**VALUE ENGINEERING SUMMARY
OF
US 119/BENT MT. TO COBURN MT.
WPI NO. 12-264.01
PIKE COUNTY, KENTUCKY**

DECEMBER 5-13, 1996

**Prepared by:
Ventry Engineering**

**Kentucky Transportation Cabinet,
Department of Highways**

GRADES

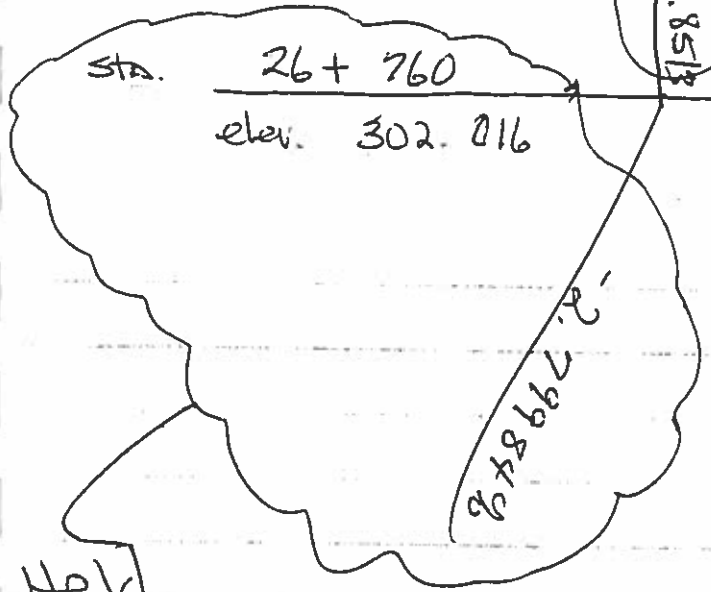
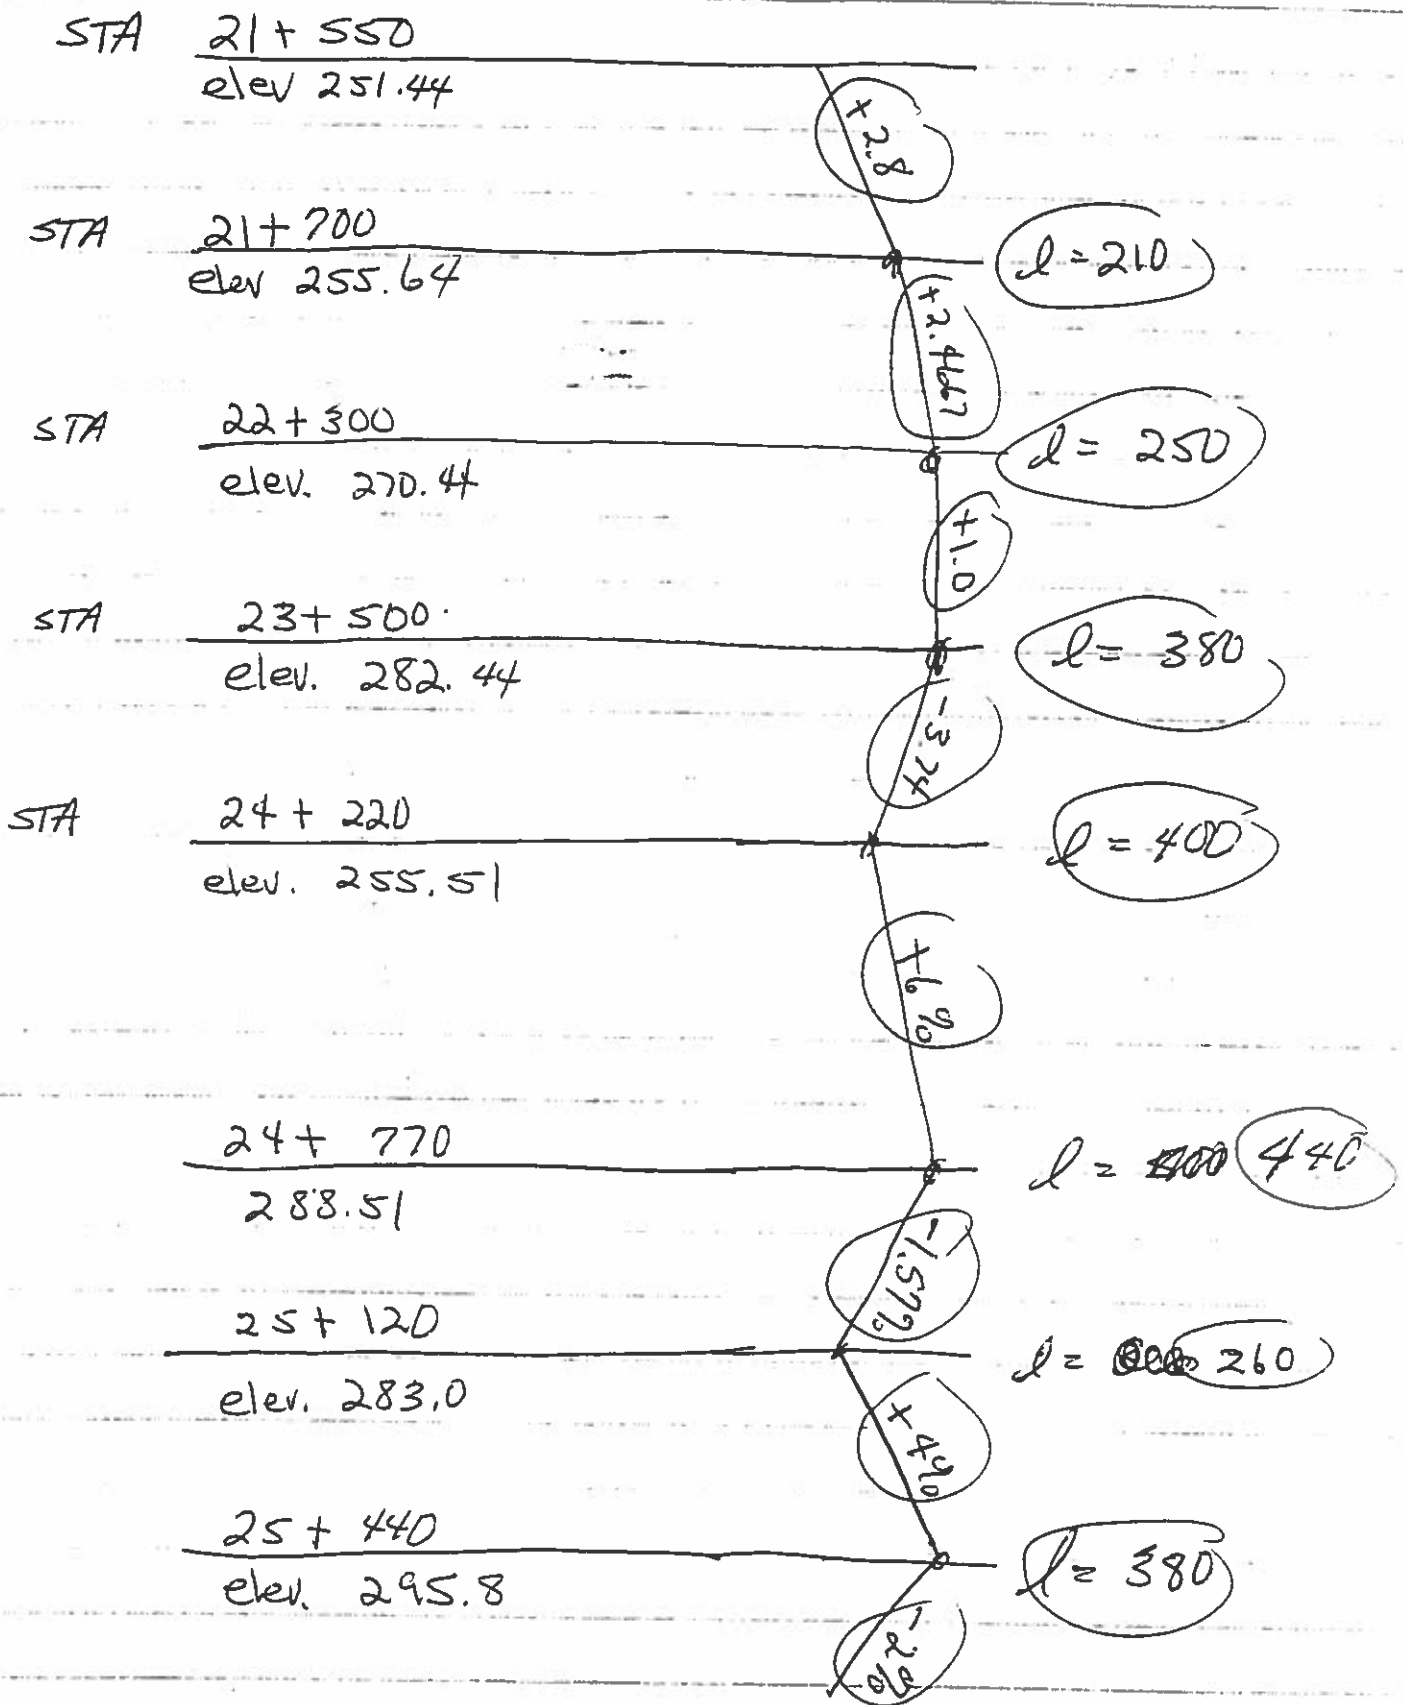
The V.E. team considered a new profile that basically ramped up at the beginning project, crossed the existing roadway at higher elevations and dipped at a centralized prospective interchange location. The profile which was studied then rose at a 6% grade after Sta. 24+200 for 550 meters. The horizontal alignment was shifted 10 meters left from Sta. 24+063 to Sta. 25+371. This shift would move the revised grade higher up the mountain reducing the volume of roadway excavation. The horizontal curve lengths were not changed because all delta angles were not revised. The number of V.P.I.'s and vertical curves were increased by 40% over the proposed design.

The earthwork was recalculated with the revised profile and indicated a savings in cut and spoil material. (See below table).

The team then reviewed the toe of slope locations to establish any right-of-way changes. This grade revision resulted in the addition of \$500,000 of retaining walls (or MSE walls). The V.E. alternative also required the bridges to be lengthened at both crossings. This resulted in the addition of \$4,747,000 of additional structure. While this alternative would save approximately \$4.5 million, the V.E. team does not recommend it, due to concerns with retaining wall on fill, the increased fill heights, additional roller coaster effect and longer bridge lengths at intersections.

ORIGINAL:	REVISED:
CUT: 1,045,317.05 cu m	869,049.65 cu m
FILL: 75,576.63 cu m	257,953.71 cu m
NET: 969,740.41 cu m	611,095.94 cu m

ORIGINAL:	REVISED:
CUT: 1,653,017.70 cu m	807,508.20 cu m
FILL: 1,347.35 cu m	81,760.40 cu m
NET: 1,651,670.35 cu m	725,747.80 cu m

ORIGINAL:	REVISED:
CUT: 3,566,999.89 cu m	2,790,572.12 cu m
FILL: 943,323.28 cu m	1,779,582.16 cu m
NET: 2,623,676.61 cu m	1,010,989.96 cu m

ORIGINAL:	REVISED:
CUT: 6,265,334.64 cu m	4,467,129.97 cu m
FILL: 1,020,247.26 cu m	2,119,296.27 cu m

NET: 5,245,087.38 cu m	2,347,833.70 cu m

AT-GRADE INTERSECTION
 STA 21+962

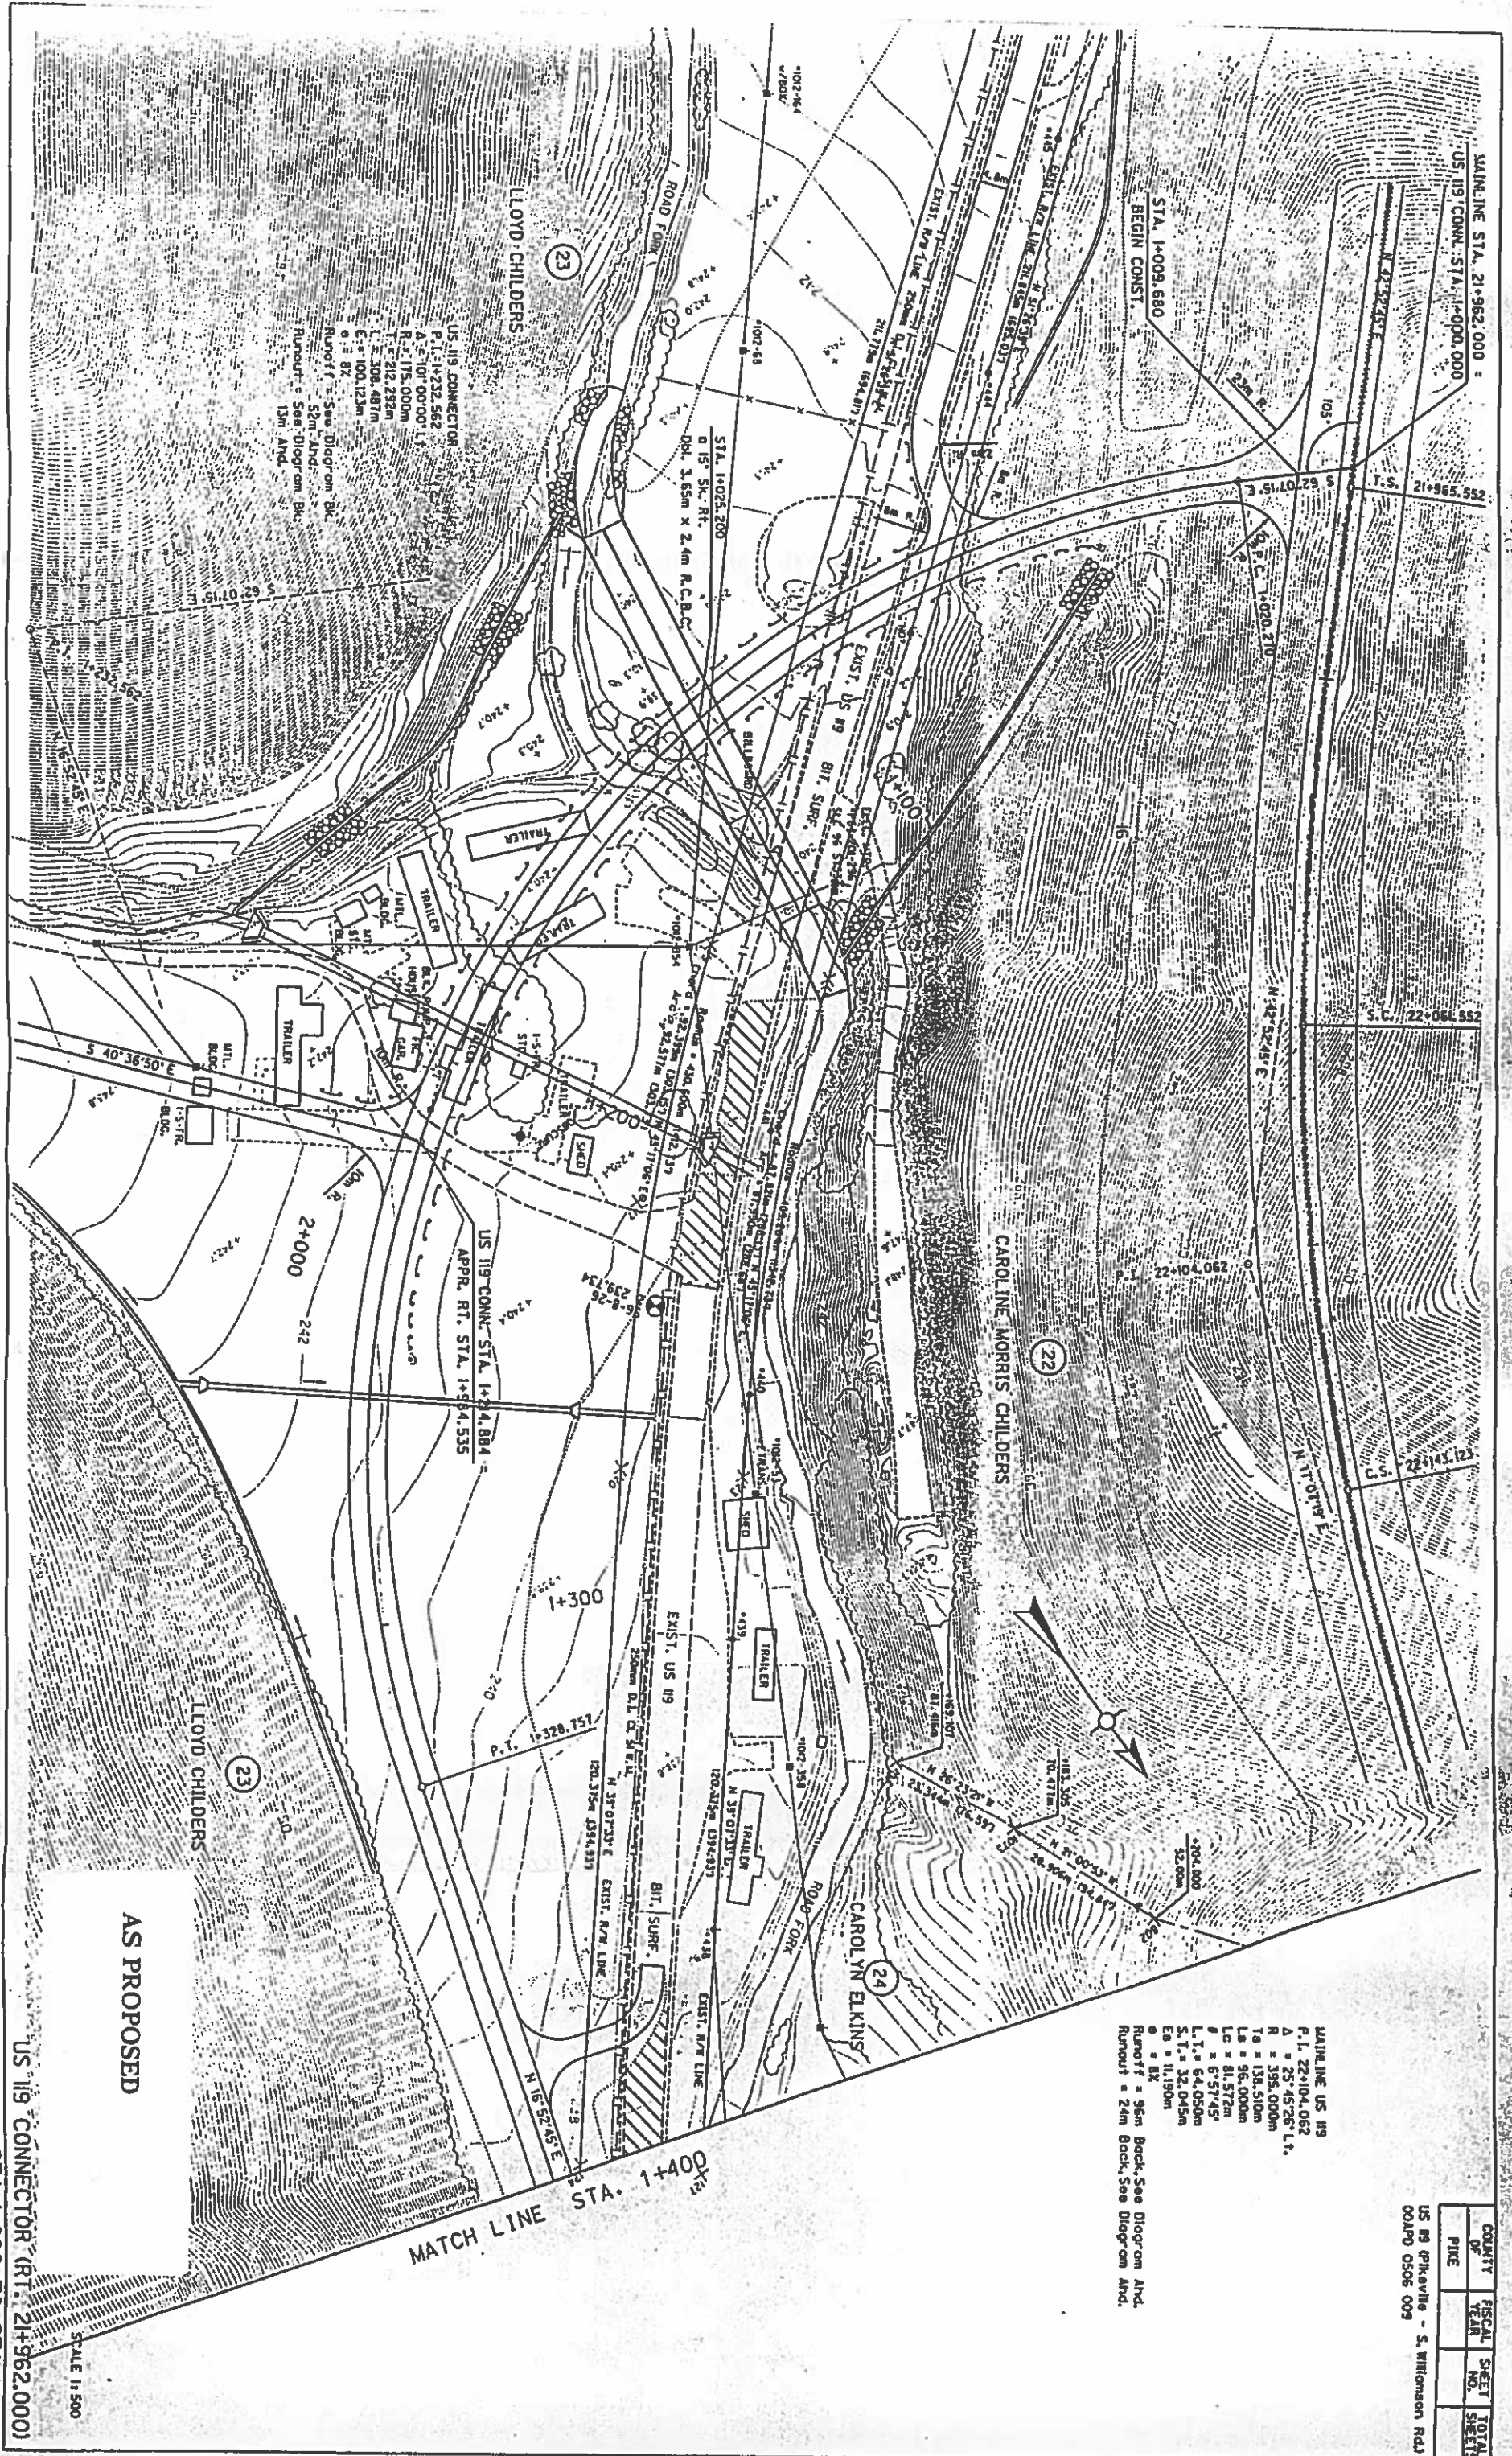
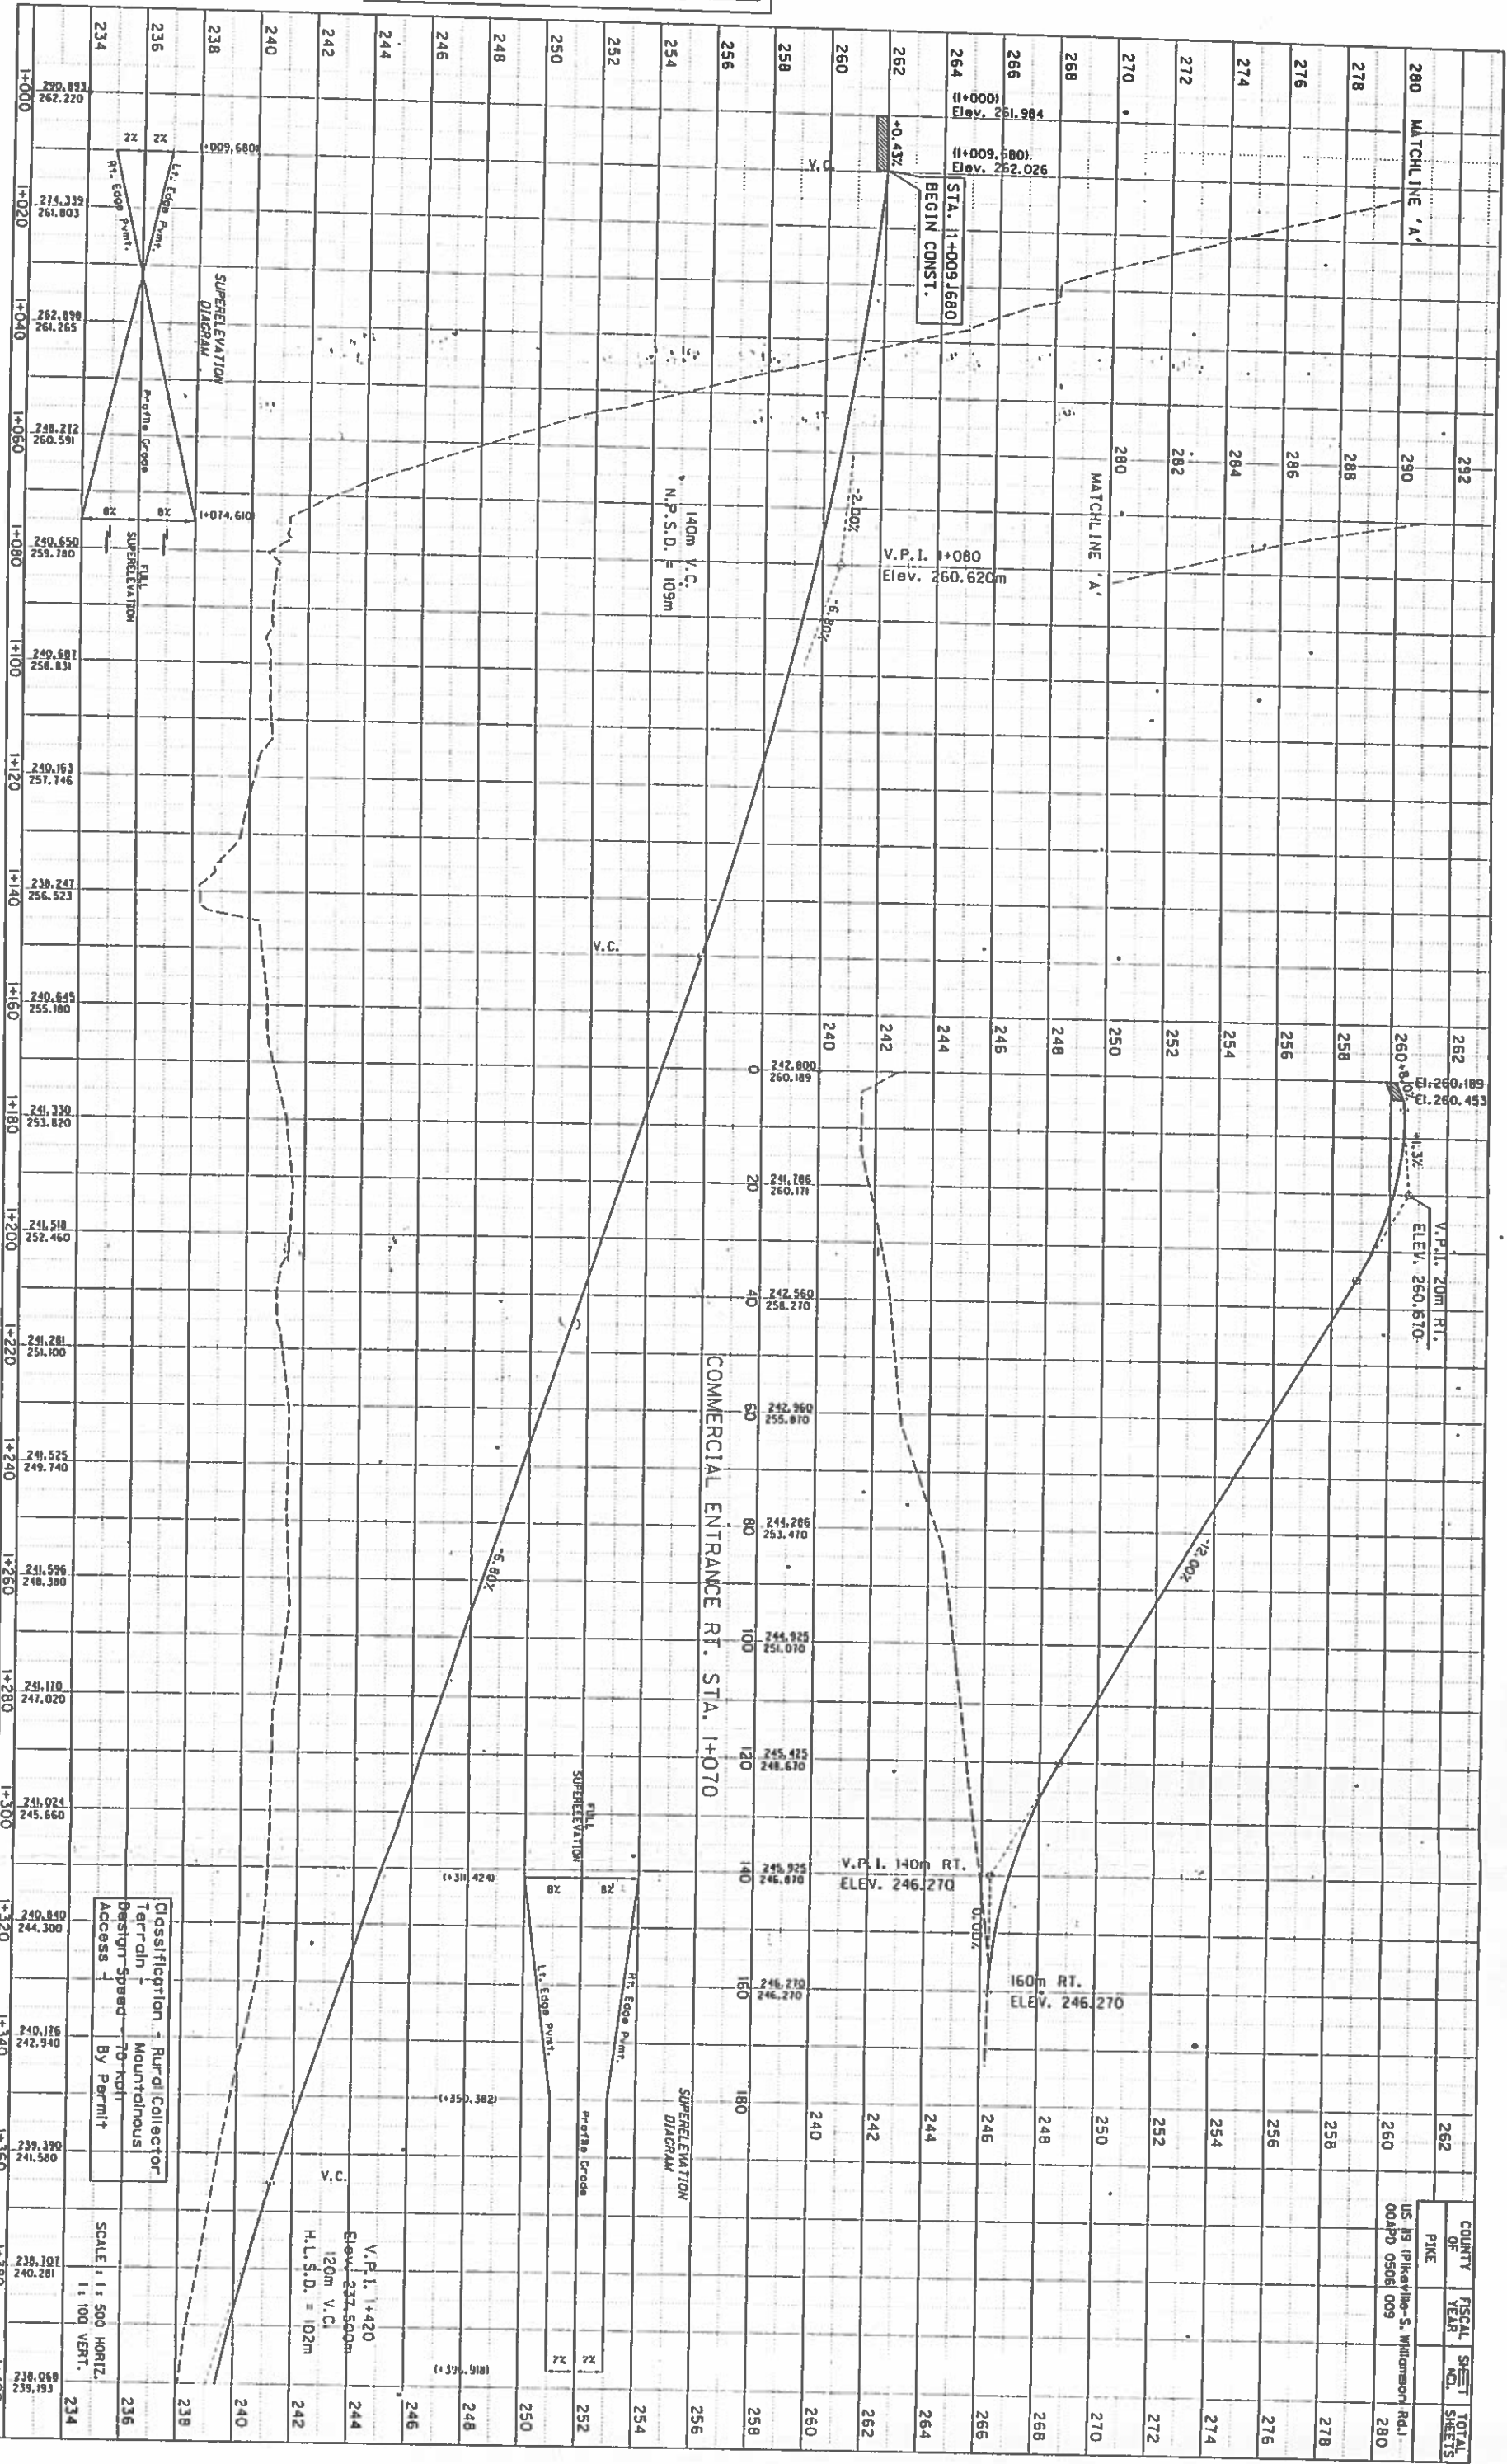
The proposed project contains an at-grade connector at station 21 + 965.552 which connects existing U.S. 119. The connector is 500 meters in length which requires construction of an embankment, maximum height of 19 meters. Right-of-way will require the purchase of two parcels and will relocate 7 families (6 trailers and one house). A double 3.65m x 2.4m X 76m R.A.B.C. will be constructed at station 1 + 125.20 at a cost of \$226,500. The construction phasing of the access roads may have considerable impact on traffic during construction.

The value engineering alternative is a grade separation interchange at approximately station 24 + 000 ± which would eliminate the two at-grade connectors at station 21 + 965.552 and sta. 29 + 200 ±. This interchange would require a single span bridge with four ramps. The approach embankments will require retaining walls on each side to allow placement of the ramps. Approximately 120 meters of roadway will be necessary to connect the existing U.S. 119 to the proposed alignment.
